Historical Architectural Review Board FINAL Review Sheet

HDC-2024-00024 Address: 340 N 8th Street District: Old Allentown Historic District Owner: Richard A Reedy Applicant: Holencik Exteriors, LLC Proposal: Replace roof

Roof Being Replaced (Applicant)

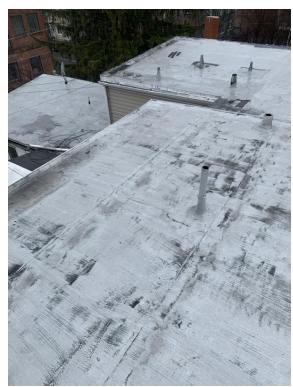
Observations & Comments: The flat roofs are not visible from the public right-of-way. The only question I have after reviewing the material is if they plan to re-line the box gutter on the front elevation with EPDM rubber roofing. Based on the design guidelines, it would be recommended that they reline the box gutter with copper sheet metal rather than covering with EPDM.

Discussion: Clarification is required with the current configuration of the box gutter, since no photographs were provided. The applicant noted the current box gutter is lined with black EPDM with a white 3-inch drip edge.

• The box gutter is re-lined with black EPDM in-kind.
